Foth & Van Dyke
Draft Technical Memorandum

RE: Additional Characteristics East-Central Region for Sub-Area A

RE: Proposal for Sub-area A and Sub-area C/D2S Dredge Prism Refinement

Reference: LFR OU1 - POG Clarification on Defining Dredge Neat Line Using GMS

REVISED FIGURE 1

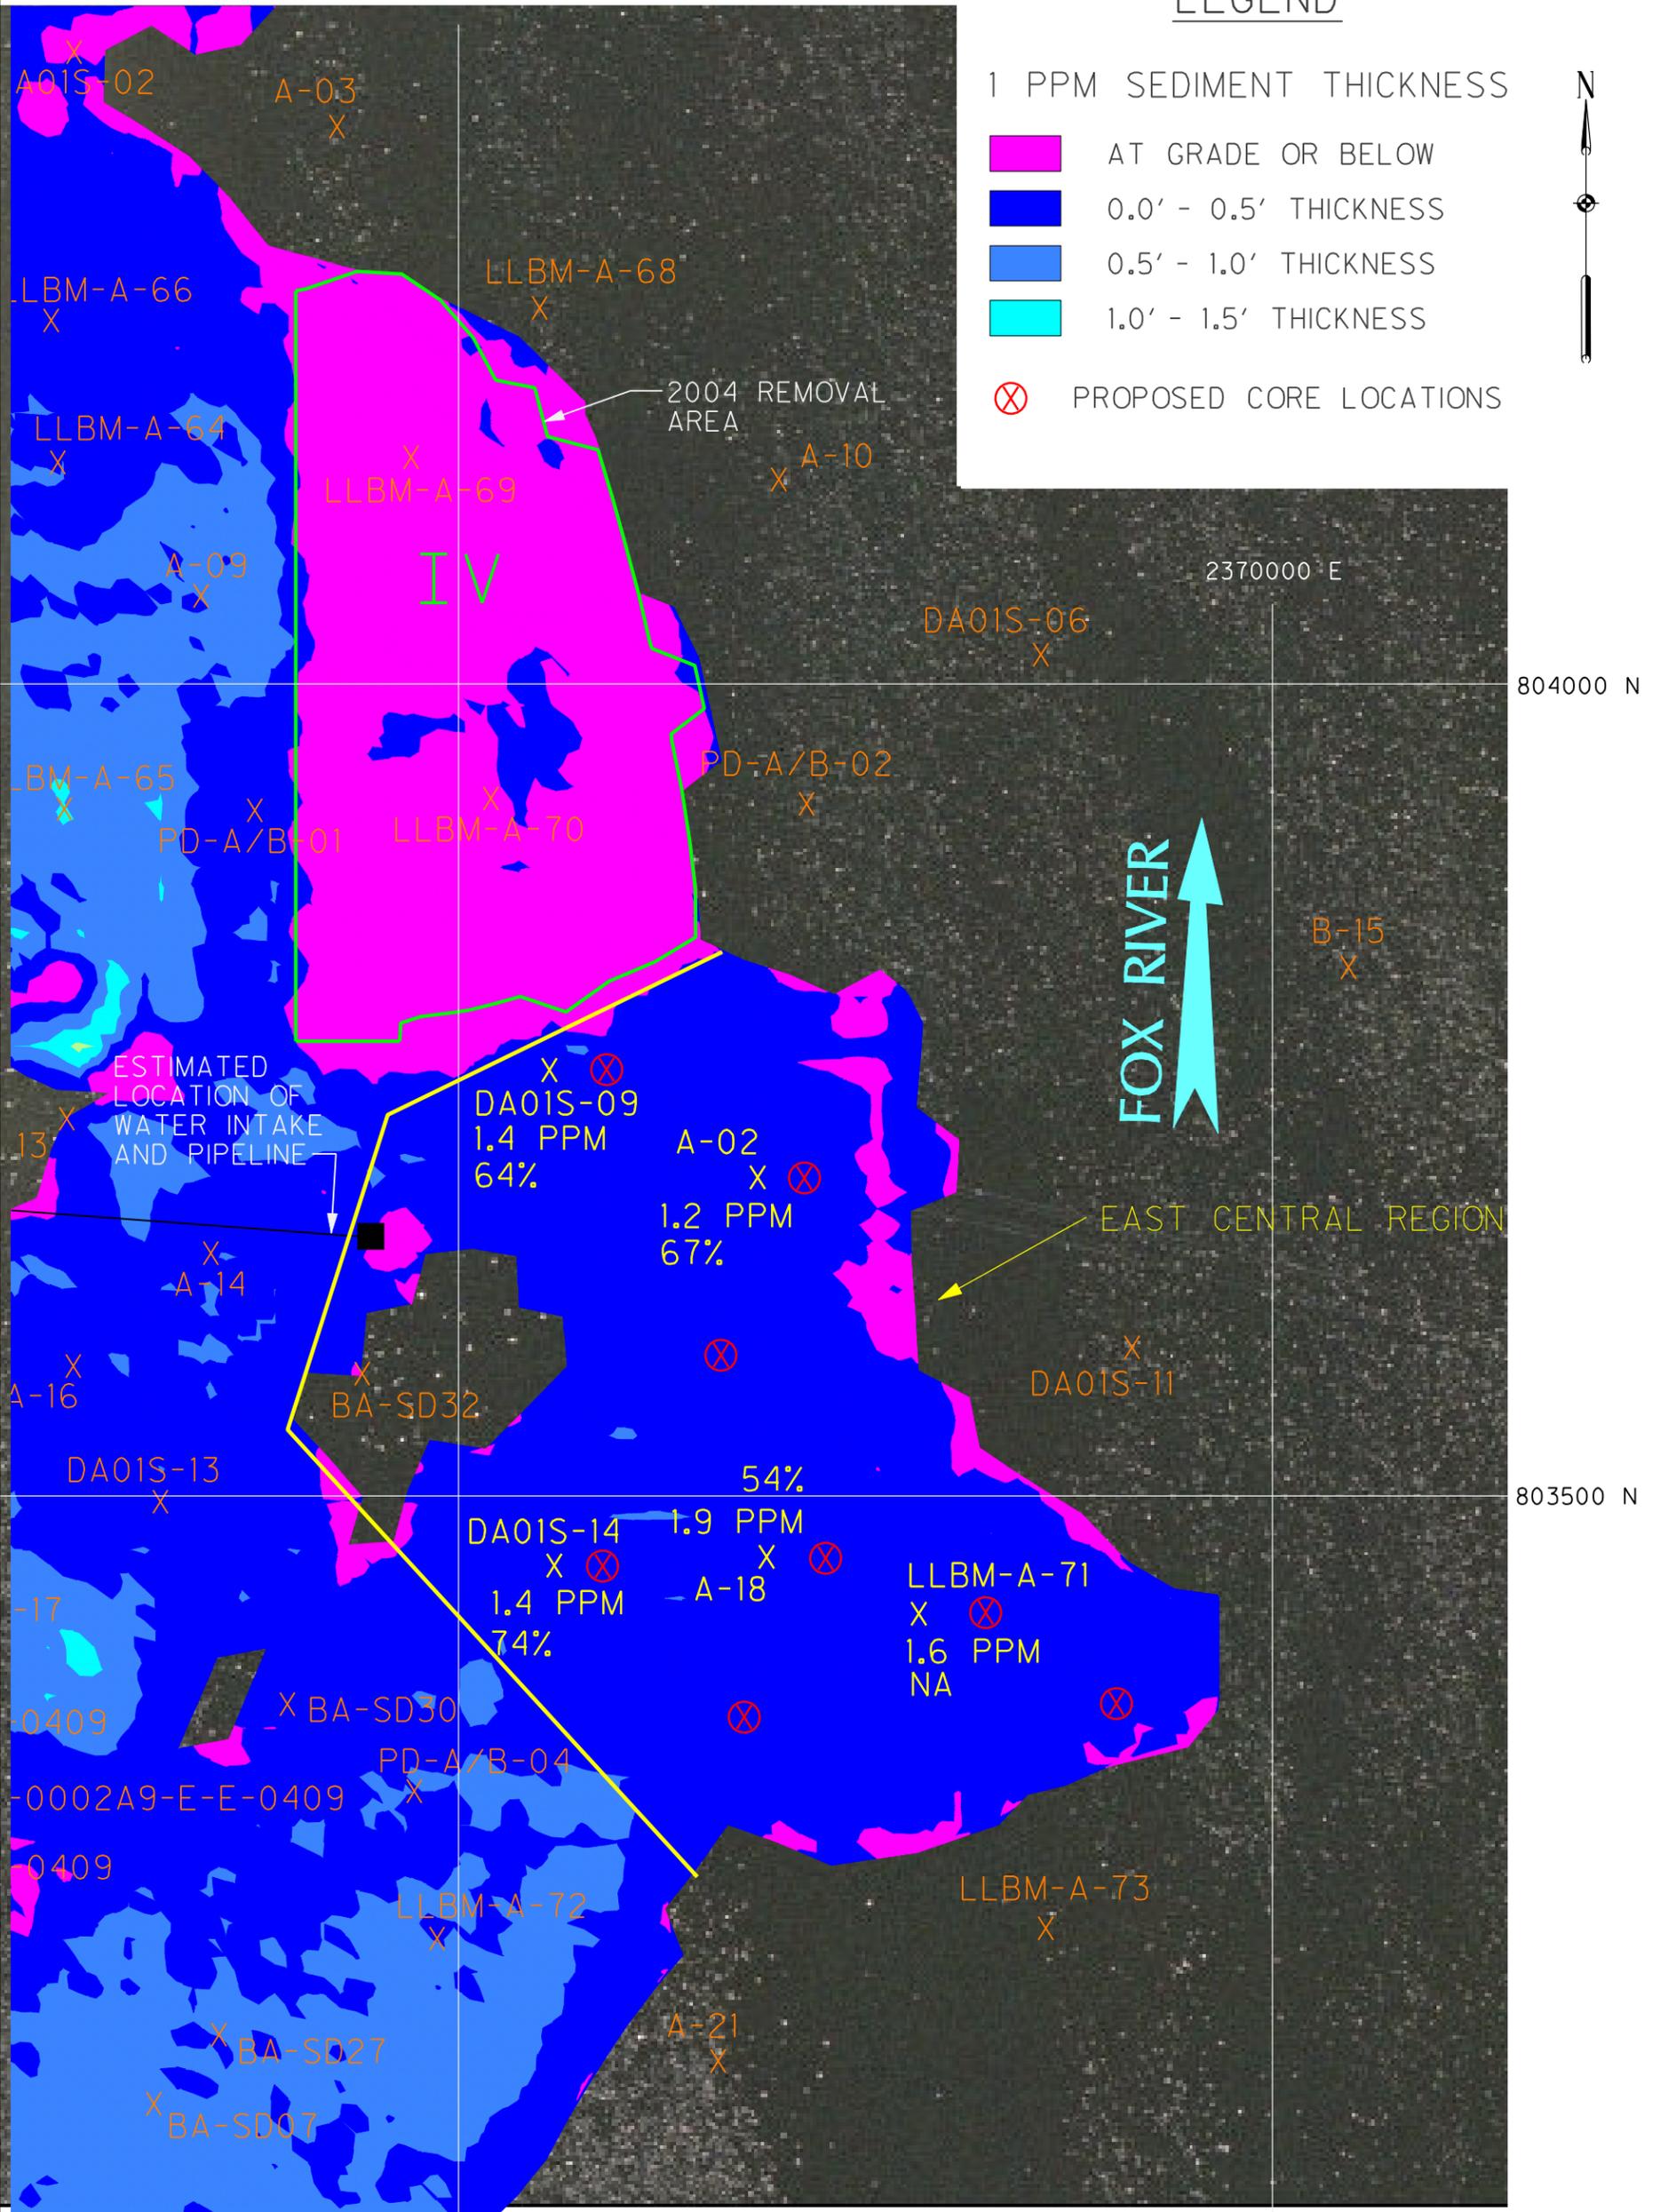
The east-central region as delineated on the attached figure is approximately 4 acres in size. In addition to an average PCB concentration of less than 2 ppm the PCB mass within this east-central-region is low in comparison to the entire Sub-area A. Sediment PCB concentrations in the adjacent area to the west of this east-central region range between 2 and 6 ppm. A summary of PCB mass metrics for this region includes:

The influence or percentage of the estimated PCB mass from the east-central region is a little less than 0.7% of the total estimated PCB mass within the 1.0 ppm PCB isopach of Sub-area A.

Removal of some or this entire east-central portion from the dredge prism would appreciably reduce the overall amount of planned material to be dredged, dewatered and disposed and would thus have a positive affect on the OU1 project.

Regarding possible dredging of “East-Central” area of Sub-Area A, representing approximately 2.5-acres: the agencies have no objection if the area shown in Figure 1 in the Memorandum regarding *Additional Characteristics East-Central Region for Sub-Area A*, by Foth and Van Dyke, dated September 22, 2005, is not dredged at this time. The reasons for not dredging this area, as we have discussed, are as follows:

1. All samples in this area have PCB concentrations less than 2 parts per million (ppm), just above the Action Level of 1 ppm, with an average concentration of 1.5 ppm. The total PCB mass for this area (the “east-central region of Sub-Area A”) is 2 kilograms, or 0.1 % of 281 kilograms PCBs within Sub-Area A.
 2. The contaminated sediment deposit is relatively thin (0.5-feet or less) with underlying sand and gravel. Thus dredging this area would be inefficient.
 3. Not dredging this 2.5-acre area would have a positive effect on the project schedule, increasing the likelihood of completion of removal of Sub-Area A this construction season.
- and
4. Dredging this area provides a relatively small environmental benefit relative to the effort required.

Foth & Van Dyke		
FIGURE 1		
Subarea A - Northern Region		
Scale:	AS SHOWN	Date: October 2005
Drawn By:	SGL	Checked By: PEP1
		Scope: 04G007

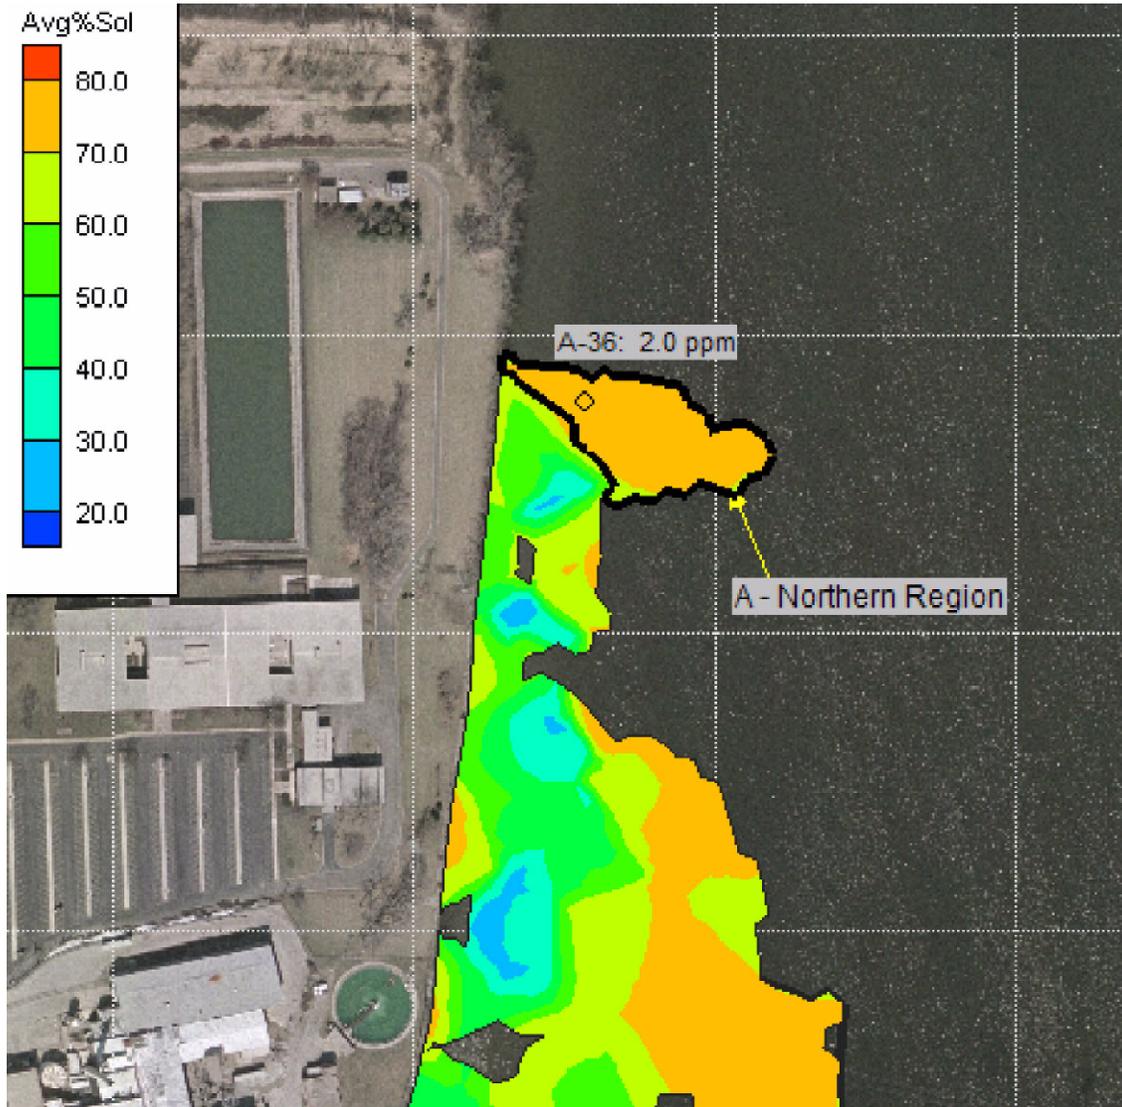
This memorandum outlines a proposal to remove portions of Sub-area A and of Sub-area C/D2S from the current dredge prisms. The portion of interest for Sub-area A is referred to as the Northern Region and is shown on Figure 1. For Sub-area C/D2S two portions are proposed for removal, namely the Southern Region of D2S and a Northern Region of C, with both regions shown on Figure 2.

Region and Sample ID	PCB Concentration	Region Area	In-Situ Percent Solids
Sub-area A: Northern Region (A-36)	2.0 ppm	59,400 sq.ft.	66%
Sub-area C: Northern Region (C-16)	1.2 ppm	39,800 sq.ft.	79%
Sub-area D2S: Southern Region (D2-19)	1.1 ppm	69,887 sq.ft.	76%

Given the considerable effort demonstrated this year to remove this type of material and the relatively low PCB mass contained in a location where a thin layer of sediment rests upon sand and gravel, it appears reasonable to remove these regions from the dredge prisms. A reduction in the dredging effort required over this combined 170,000 sq. ft. is significant to the project schedule, given the daily target dredge rate of approximately 30,000 square feet per day.

Regarding possible dredging of "Northern Region" of Sub-Area A (or A-36), "Northern Region" of Sub-area C (or C-16), and "Southern Region" of Sub-area D2S (or D2-19): the agencies have no objection if these areas are not dredged at this time. These areas are shown in Figures 1 and 2 in the Draft Technical Memorandum regarding *Proposal for Sub-area A and Sub-area C/D2S Dredge Prism Refinement*, by Foth and Van Dyke dated October 19, 2005, representing a total of 179,500 square feet. The reasons for not dredging this area as we have discussed, are similar to those discussed in my letter to you dated October 4, 2005, and described in the Memorandum referenced above.

Figure 2. Schematic of sediment profile, showing extent of sampling, poling, and GMS-SED modeling results for a thin zone of organic silt underlain by a soft clay layer (Foth & Van Dyke and Associates).

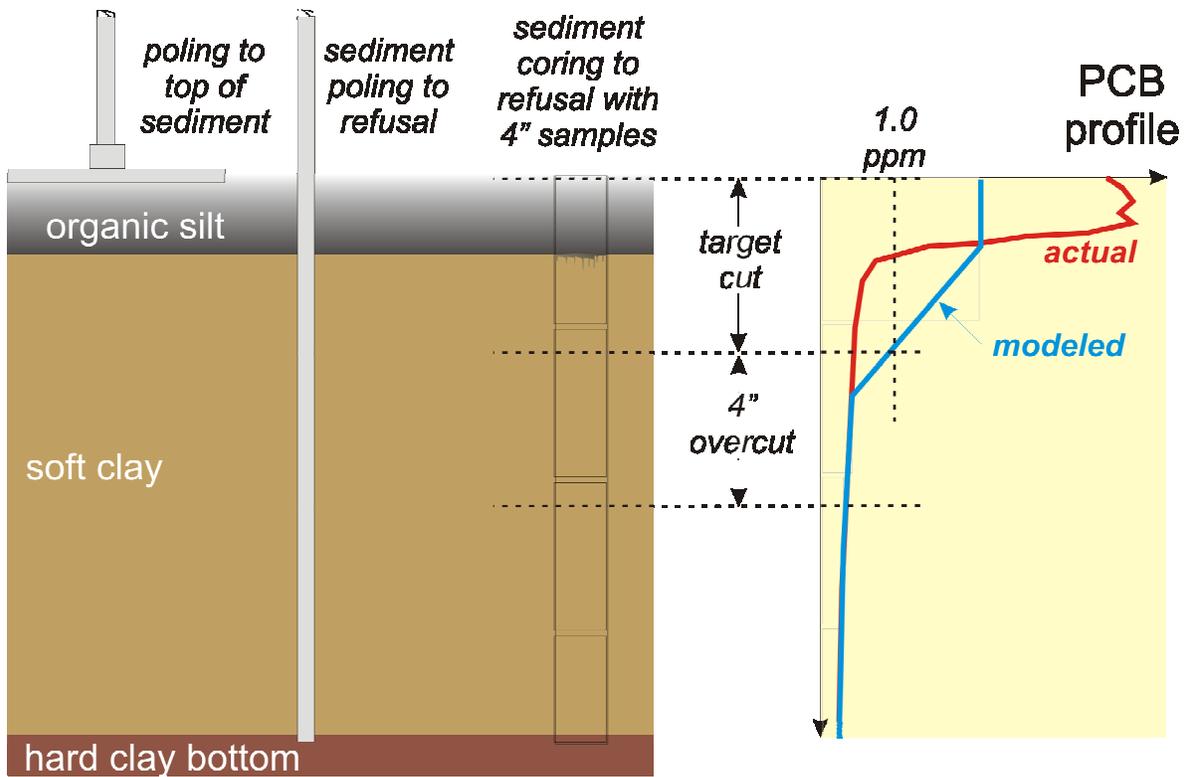
Figure 2 illustrates how the soft clay can affect the neat line (Errors associated with the survey elevation, sample recovery, and analytical errors are ignored for this illustration). Poling is used to define the zone of soft sediment and sampling results are interpolated within the model to prescribe the cut at the poling location. When there is a thin zone of contamination not fully extending through the sample interval, the model overestimates the depth of PCB contamination. Similarly, overestimating the thickness of the extent of soft sediment tends to drive the modeled neat line down into the soft clay layer. These two occurrences result in a conservative approach to RAL elevation establishment.
